153-157 Walker Street Response to DPHI and NS Council Comments

1. Response to DPHI Comments

Response to DPHI Comments

Proposed Setbacks – Eastern Setback (to Little Walker Street)

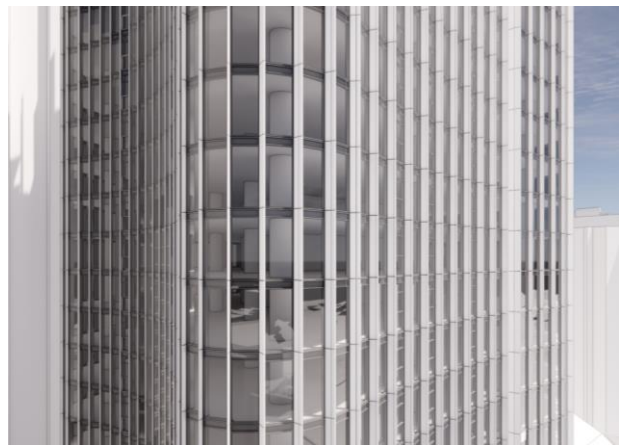
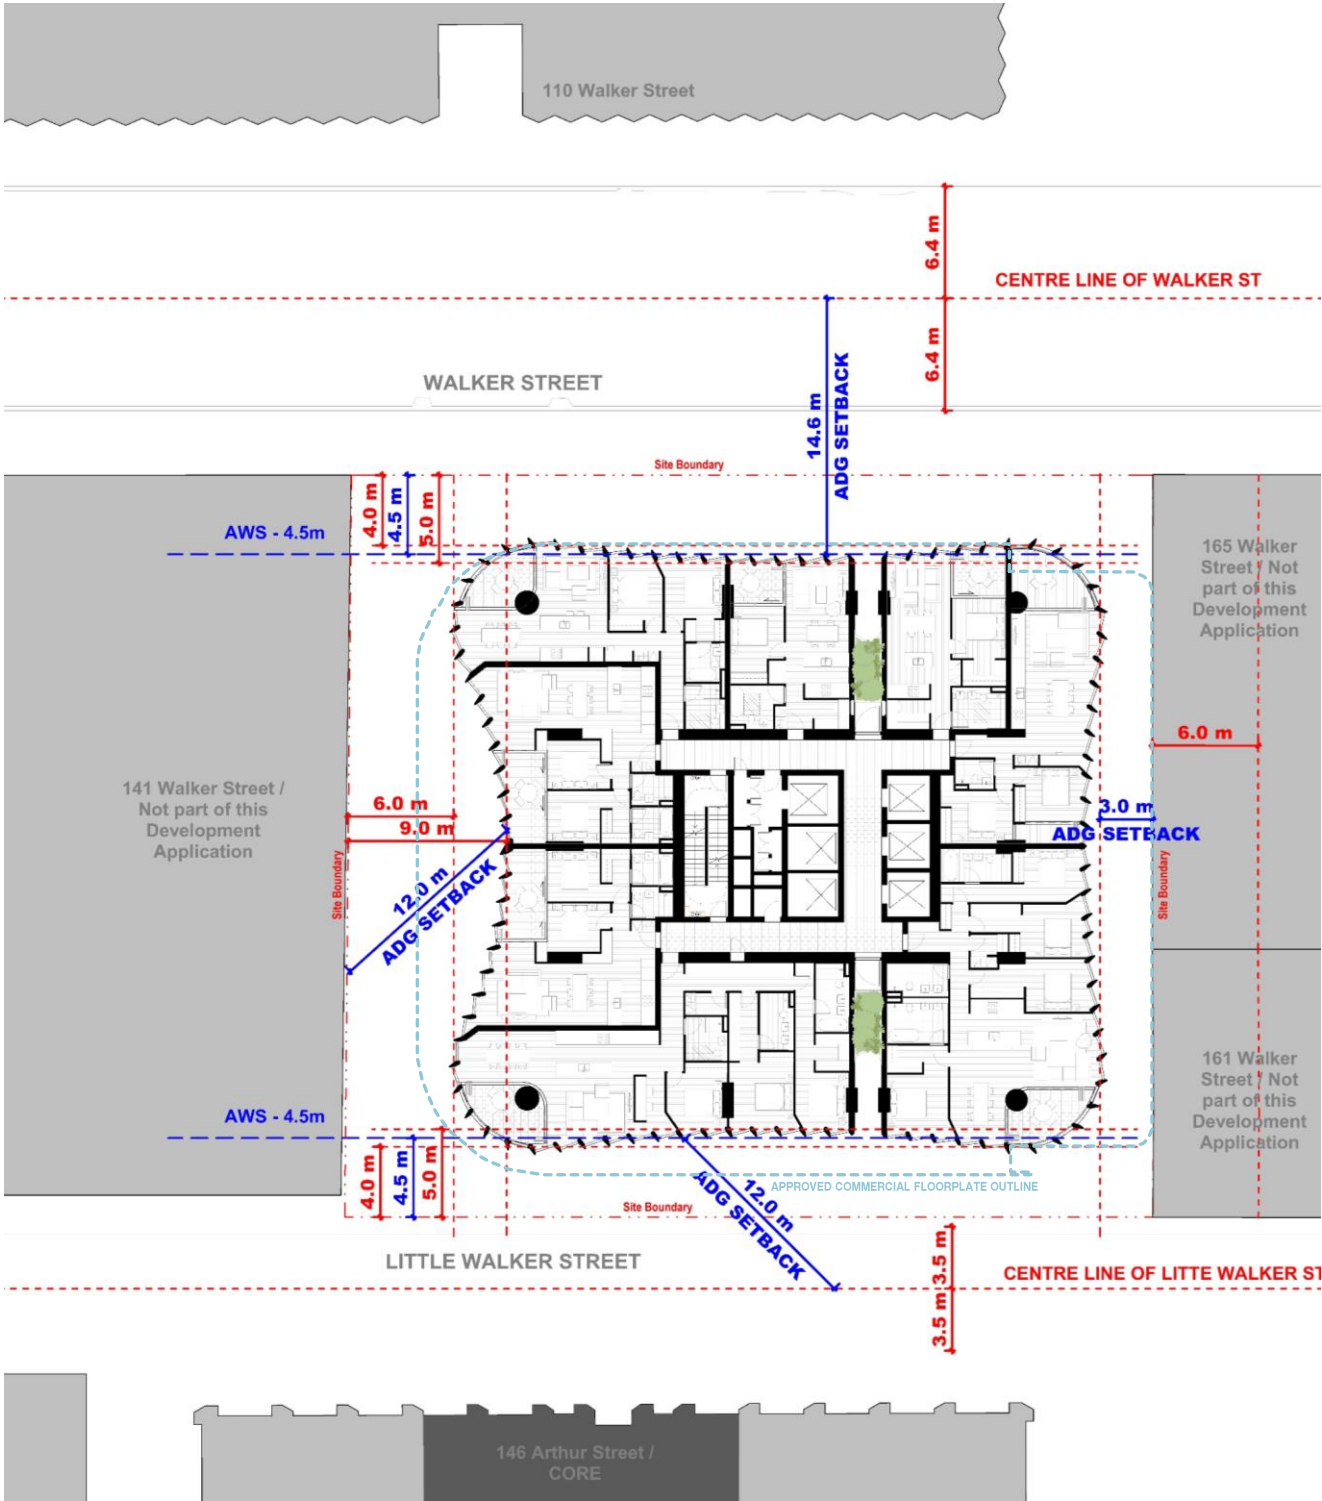
A. Building setbacks fall well short of Apartment Design Guide (ADG) minimums, leading to overshadowing, privacy loss, reduced daylight, and negative impacts on neighbouring commercial towers.

The Eastern setback at 153–157 Walker Street demonstrates full compliance with the building separation requirements of the Apartment Design Guide (ADG) Part 3F, Clause 3F-4: Side and Rear Setbacks for buildings over 25m in height. The ADG requires a minimum 24m tower separation, achieved through a 12m setback from the shared boundary on each site. When measured perpendicularly from the glazing line (the primary dwelling façade) to the centre line of Little Walker Street, the setback is 12m, ensuring that our development alone satisfies the ADG tower separation requirement irrespective of any setback provided by the adjoining property at 146 Arthur Street.

Furthermore, the design addresses potential amenity impacts through a carefully considered architectural stratagem that integrates vertical louvres into the eastern façade. While the proposed boundary setback is consistently generous, the vertical louvers and angled windows have been purposefully designed to deflect views away from direct sightlines toward the approved development at 146 Arthur Street. This deliberate design measure mitigates any concerns regarding visual privacy and overlooking in accordance with ADG 3F-4 (A2).

The louvers operate as a permanent architectural screening device that safeguards residential amenity for both developments. This approach not only complies with the numerical requirements of the ADG but also clearly achieves its performance objectives for visual privacy and urban amenity within a high-density CBD context

Proposed Setbacks – Western Setback (to Walker Street)

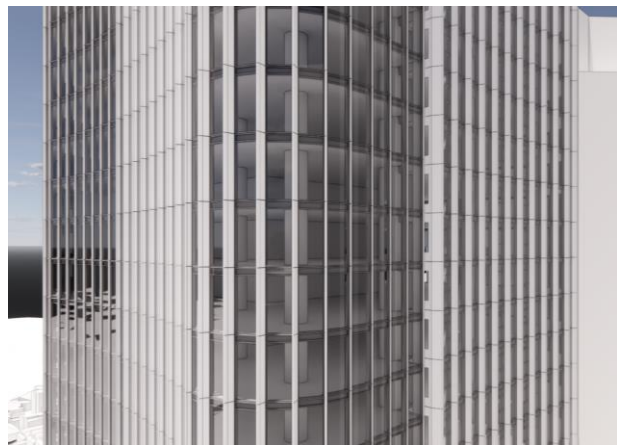
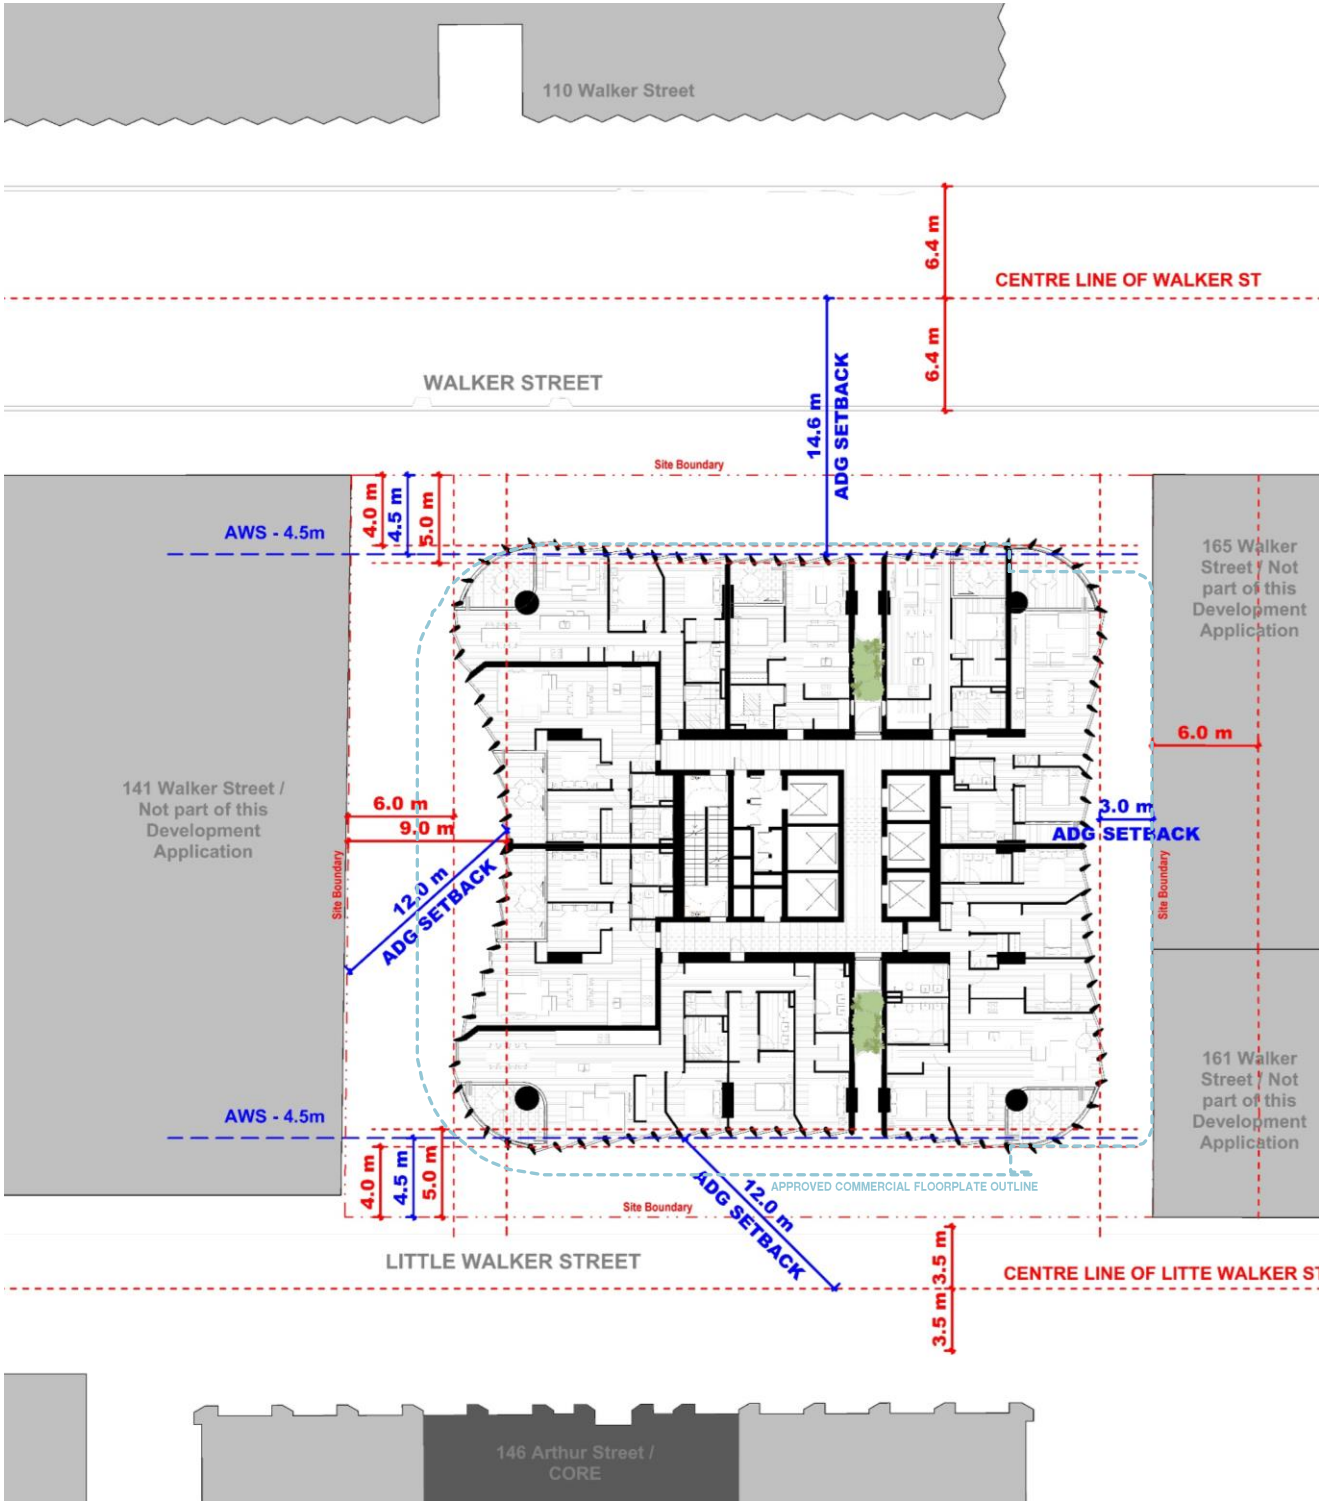
A. Building setbacks fall well short of Apartment Design Guide (ADG) minimums, leading to overshadowing, privacy loss, reduced daylight, and negative impacts on neighbouring commercial towers.

The ADG mandates a minimum 24 m separation between towers. The Western setback is measured from the centreline of Walker Street to the glazing line of the proposed façade. The submitted architectural plans clearly demonstrate setback of 14.6 m from the centreline to the site boundary (29.2m total), ensuring compliance with the applicable setback provisions.

Beyond meeting the numerical criteria, the design incorporates a deliberate façade and mullion strategy that is integral to achieving the ADG’s performance objectives. The articulation of the western façade has been expressly designed to angle and orient views away from the adjacent development at 110 Walker Street.

Proposed Setbacks – Northern Setback (to 161 and 165 Walker Street)

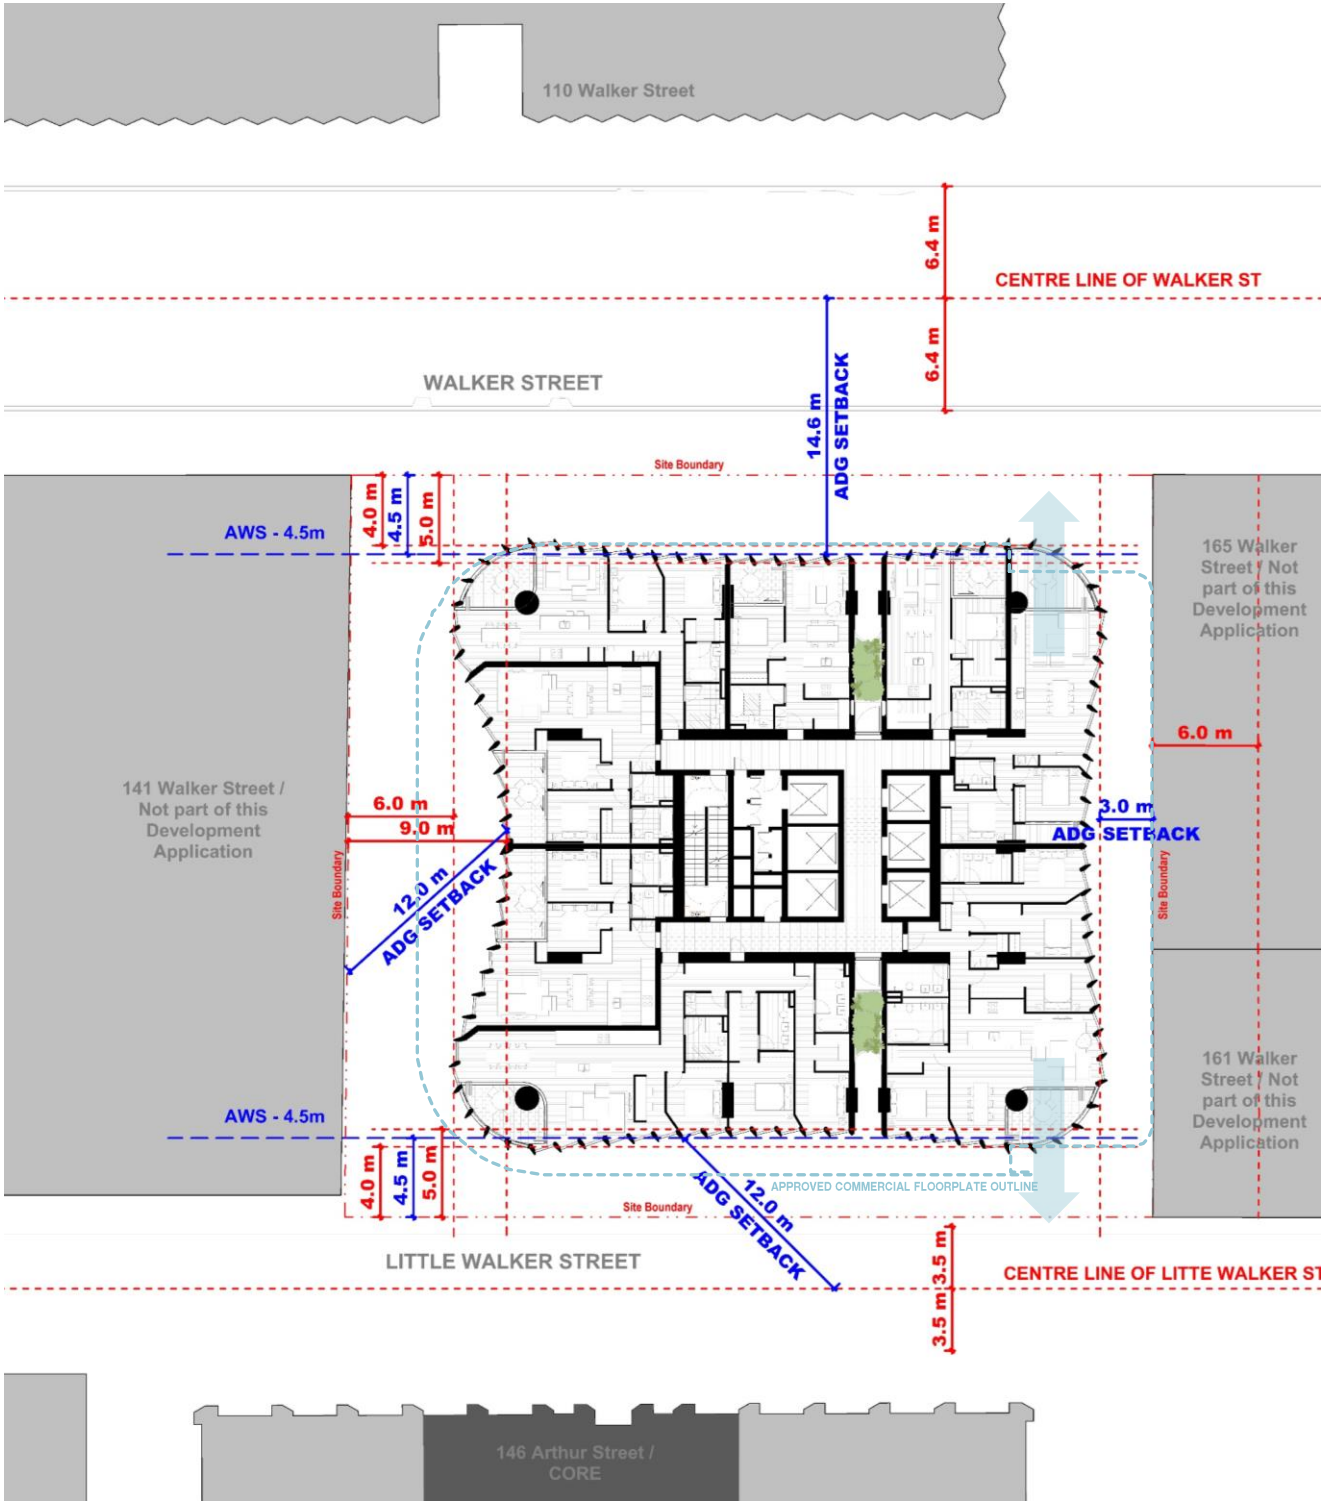
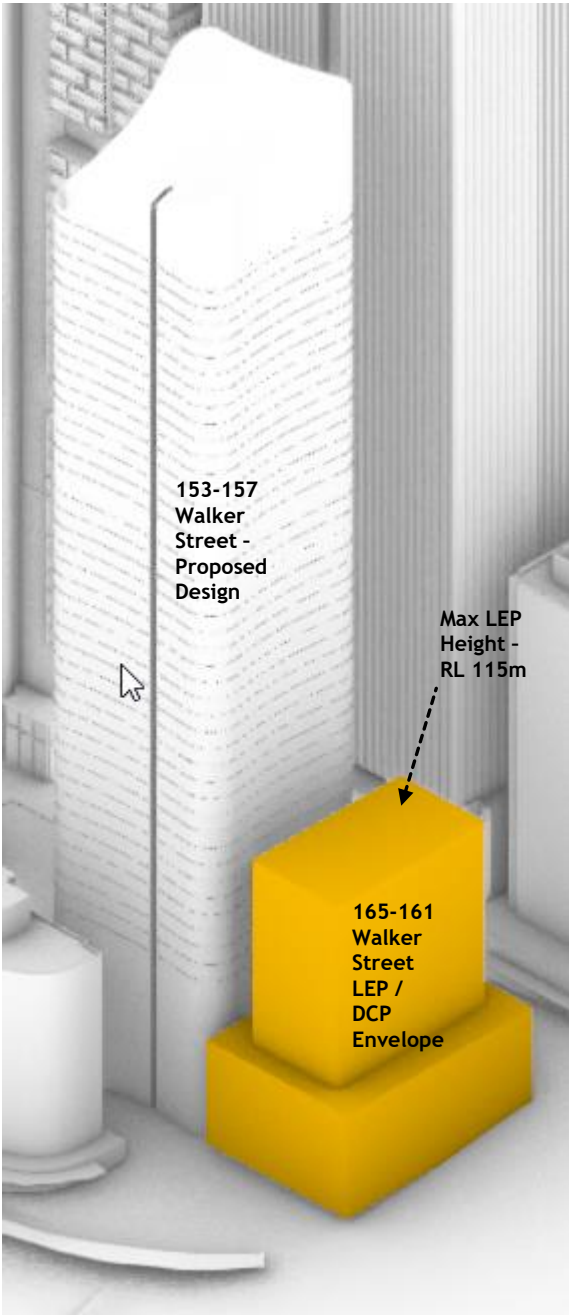
A. Building setbacks fall well short of Apartment Design Guide (ADG) minimums, leading to overshadowing, privacy loss, reduced daylight, and negative impacts on neighbouring commercial towers.

The Northern Elevation setback is designed to achieve the performance objectives of the Apartment Design Guide (ADG) regarding visual privacy and building separation, particularly concerning blank walls, while respecting the existing planning controls for the neighbouring site.

The design provides a 3.0m setback from the northern site boundary, which is significantly enhanced compared to the previously approved commercial scheme for this site (that featured nil (0m) setback). Therefore, the current residential proposal, by providing a 3.0m setback, demonstrates superior separation and a reduced visual impact when compared to the established planning precedent, whilst providing appropriate fire separation in accordance with NCC.

The Northern Elevation also incorporates a full-height vertical louvering system, consistent with the other facades, which has an appearance of a blank wall, when viewed perpendicularly to it. However in this case this is predominantly an aesthetically consistent approach and solar heat radiation mitigating design, as the neighbouring development can only be developed up to RL 115.

Commercial Tower Originally Submitted DA

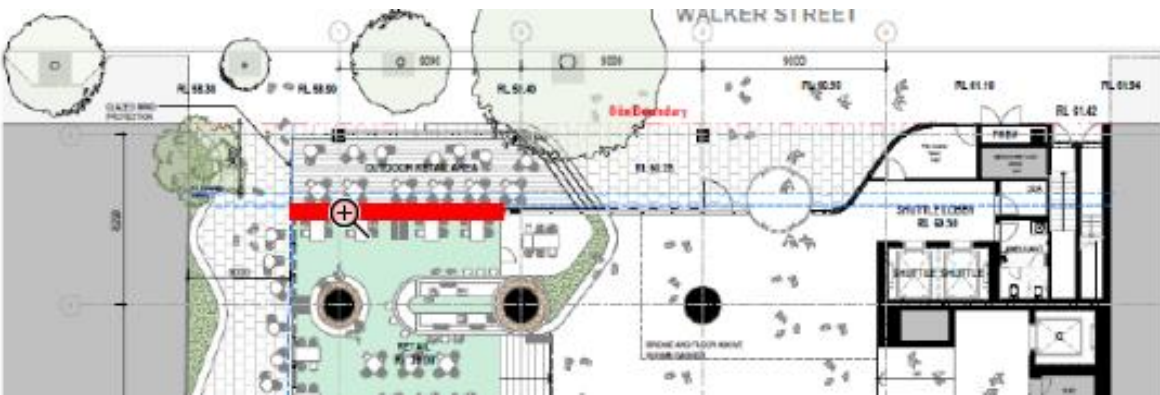
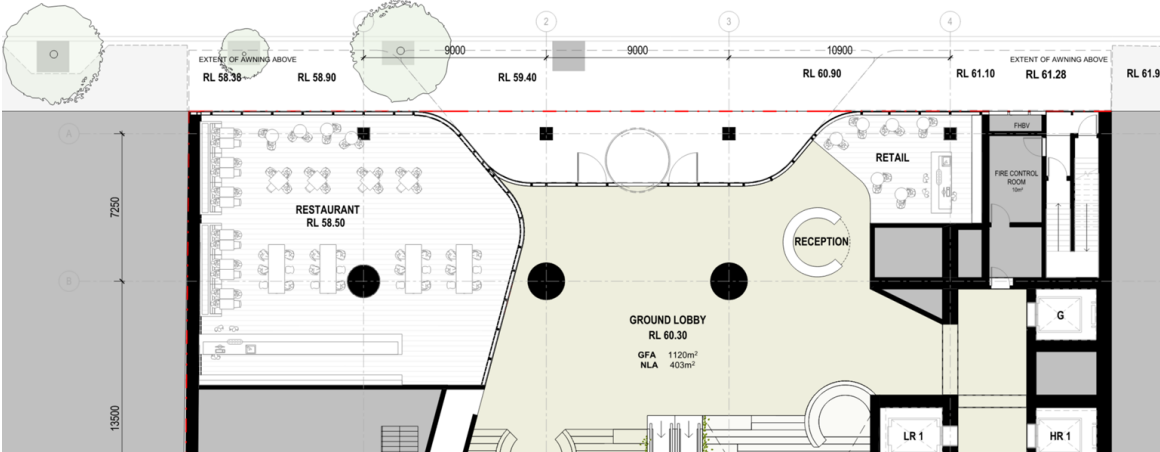
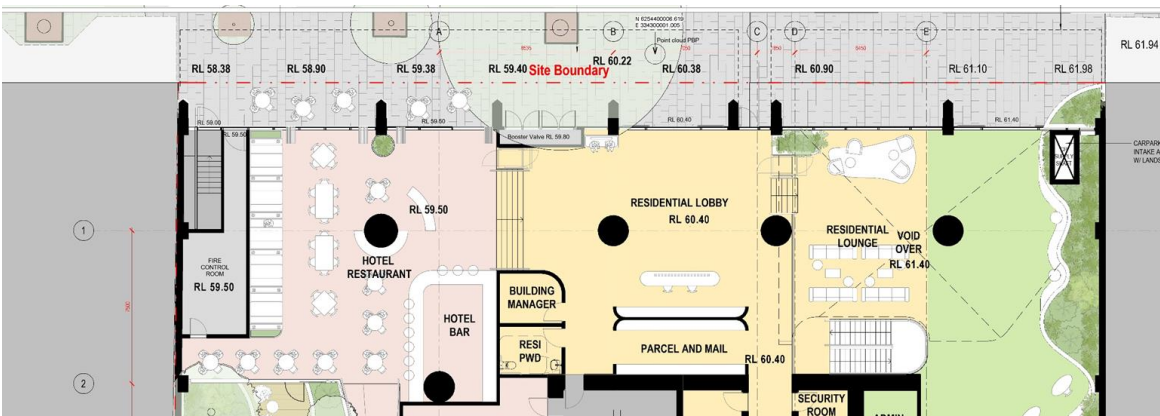
C. Podium height and streetscape elements are inconsistent with local controls, reducing human-scale street interface.

The podium form of the lodged design in regards to height and setback is equivalent to the podium form of the approved Commercial design for the subject site. The podium of the lodged design comprises of compliant podium setbacks, and its height refers to the height of the approved commercial scheme. A podium built to boundary and compliant podium height was requested by North Sydney Council part of the Section 34 negotiation process and it was one of the conditions of consent.

Importantly, the proposed design maintains the podium setback strategy adopted by the currently approved commercial scheme under the Section 34 agreement. This ensures continuity with the endorsed planning envelope, reinforces the intended street wall condition, and delivers a podium configuration consistent with Council's negotiated outcome for the site.
